HISTORIC AND DESIGN REVIEW COMMISSION

August 05, 2020

HDRC CASE NO: 2020-331
ADDRESS: 251 FURR DR
LEGAL DESCRIPTION: NCB 6699 BLK 8 LOT 13
ZONING: R-6,H
CITY COUNCIL DIST.: 7
DISTRICT: Monticello Park Historic District
APPLICANT: LEO G & SANDRA L GIBSON
OWNER: LEO G & SANDRA L GIBSON
TYPE OF WORK: Removal of planting strip and installation of flagstone
APPLICATION RECEIVED: July 17, 2020
60-DAY REVIEW: Not applicable due to City Council Emergency Orders
CASE MANAGER: Stephanie Phillips

The applicant is requesting a Certificate of Appropriateness to remove the turf grass in the planting strip and install flagstone.

Photo (1 of 2) of site to be paved. Please refer to site plan for details and measurements.

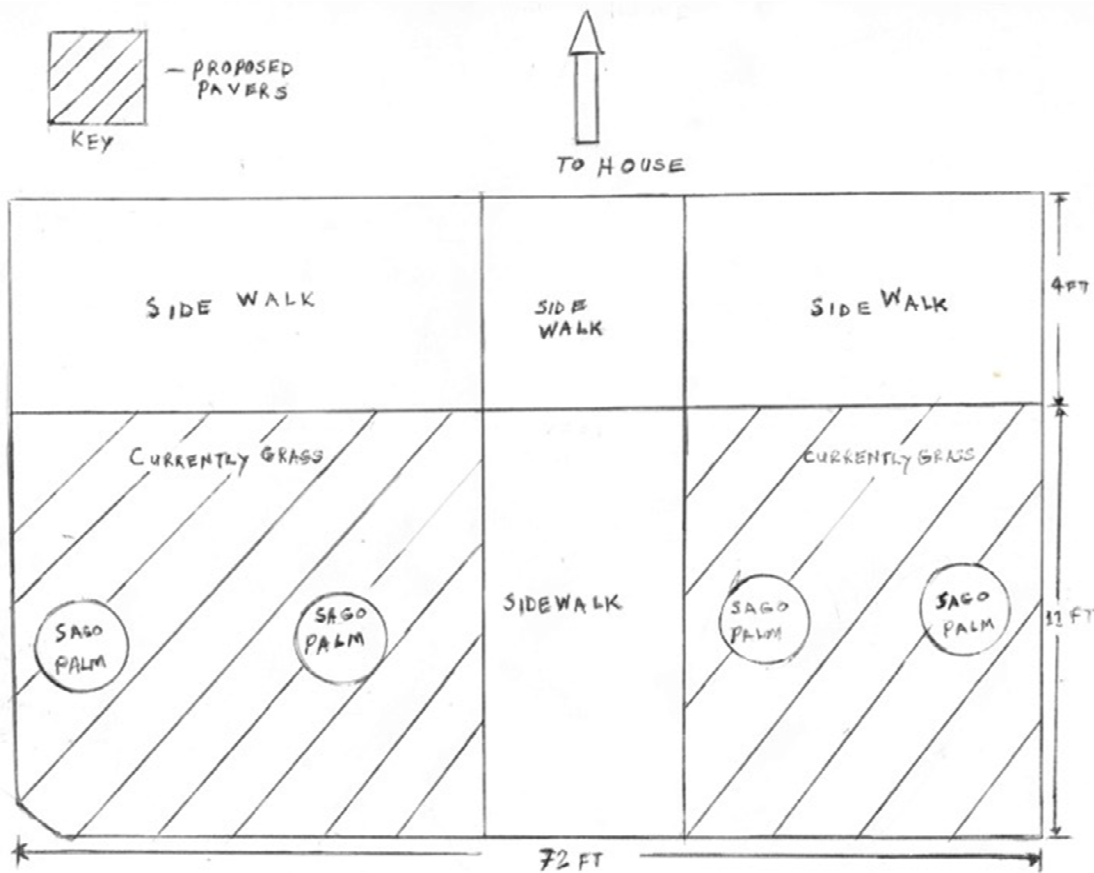
- b. PLANTING STRIP HARDSCAPING – The applicant has proposed to remove the planting strip, the portion between the sidewalk and street, and install a continuous run of flagstone. The existing sago palms will be retained per the submitted site plan, but no additional plants or greenery are proposed as part of the modifications. Previously, this area featured turf grass, but recent right-of-way improvements have damaged this area and an irrigation system per the applicant. According to the Guidelines, the use of traditional lawn in planting strips or low plantings where a consistent pattern has been retained along the block frontage should be maintained. If mulch or gravel beds are used, low-growing plantings should be incorporated into the design. Based on a windshield survey of the area, flagstone in the planting strip location is not a condition extant in the district. While staff finds that the removal of grass in favor of sustainable xeriscaping or drought-resistant, native, low-growing groundcover is appropriate, staff does not find the wholesale removal of greenery and the installation of flagstone, an impermeable surface, consistent with the Guidelines.

Staff does not recommend approval based on finding b. A plan that incorporates at least 50% greenery and pervious cover in the planting strip is eligible for administrative approval.
